**To:** Patterson, Leslie[patterson.leslie@epa.gov]  
**Cc:** Brett Fishwild[Brett.Fishwild@CH2M.com]  
**From:** Marshall, Laura  
**Sent:** Thur 3/14/2013 3:00:07 PM  
**Subject:** RE: SDDL Phase 1A outline comments

**Subject:** SDDL Phase 1A outline comments

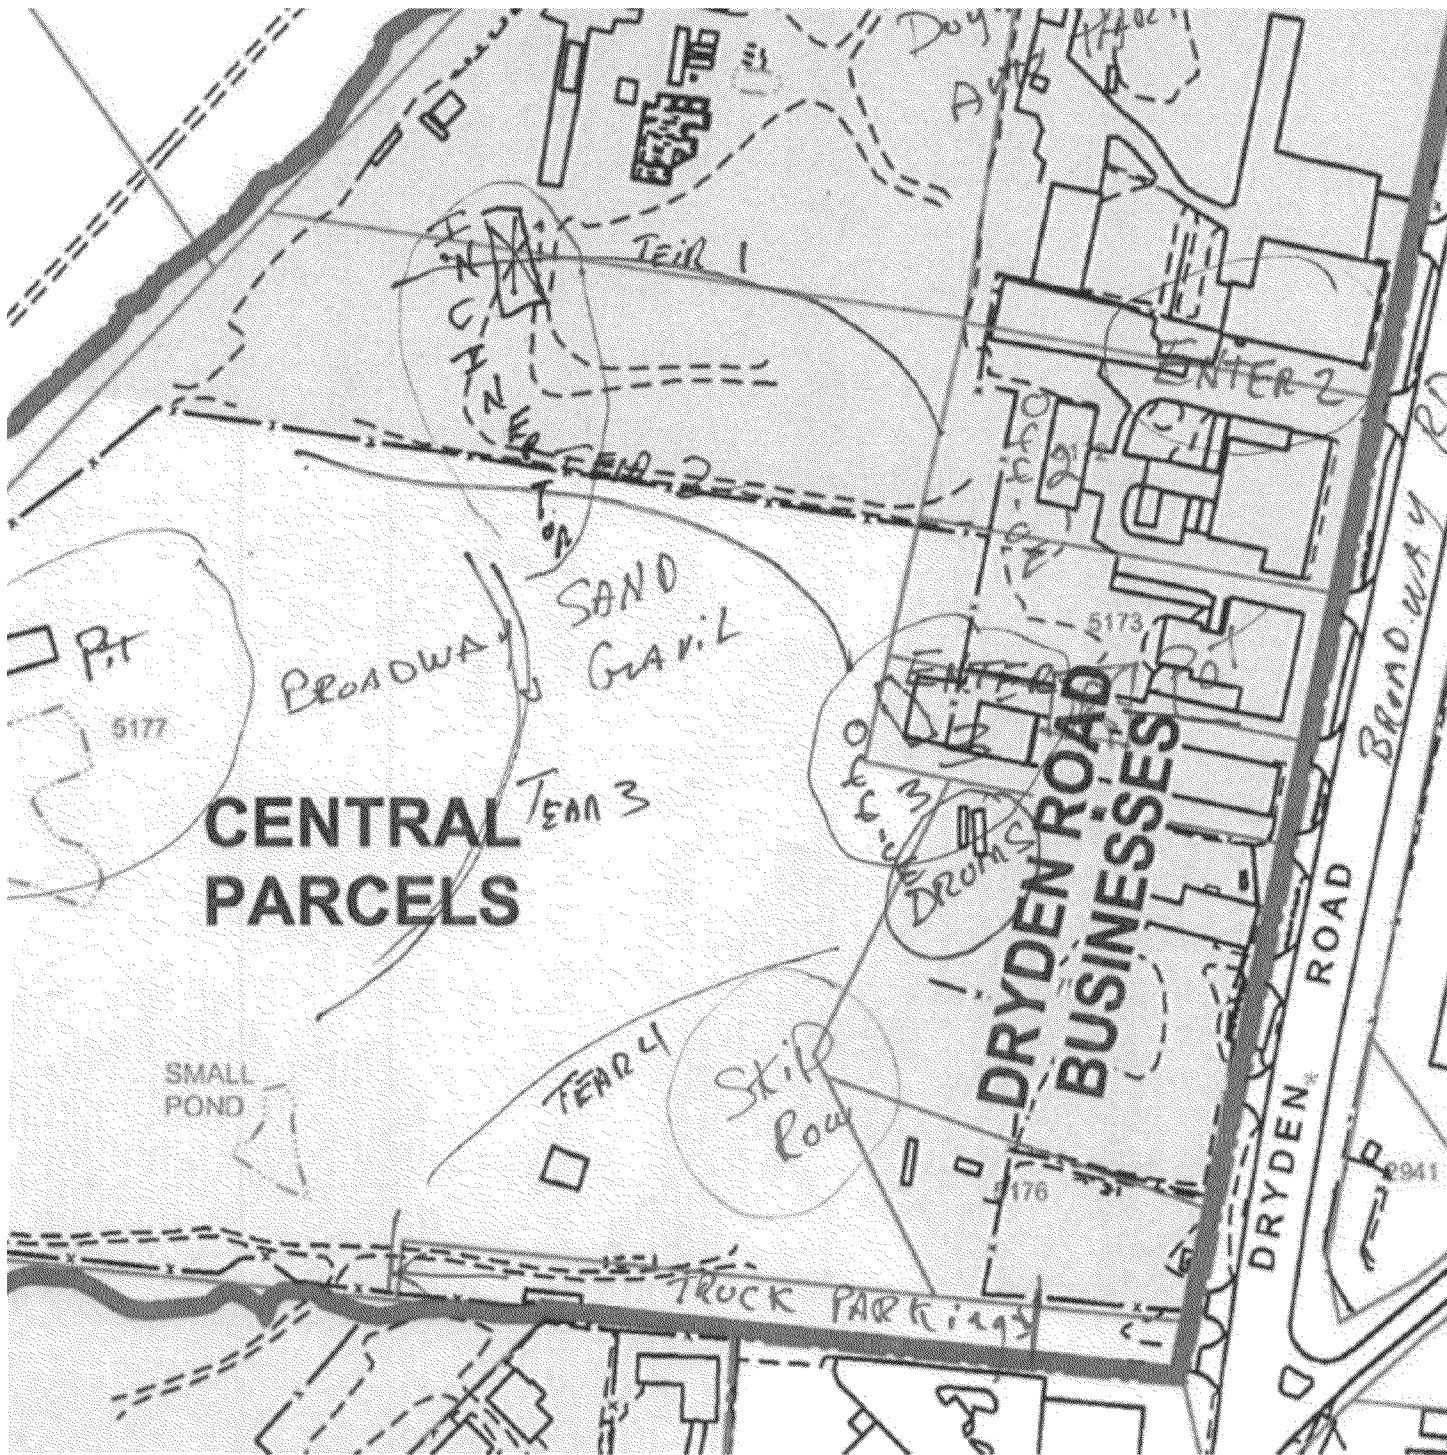
Sure, here's the portion of the Grillot deposition Exhibit 2 that shows drums south of the Entrance 3 office. The transcription of the deposition talks about drums dumped "behind" entrance 3 though, so where that might have happened in relation to the office is a bit unclear. The area of concern would be the area around the office down to the area marked "drums".
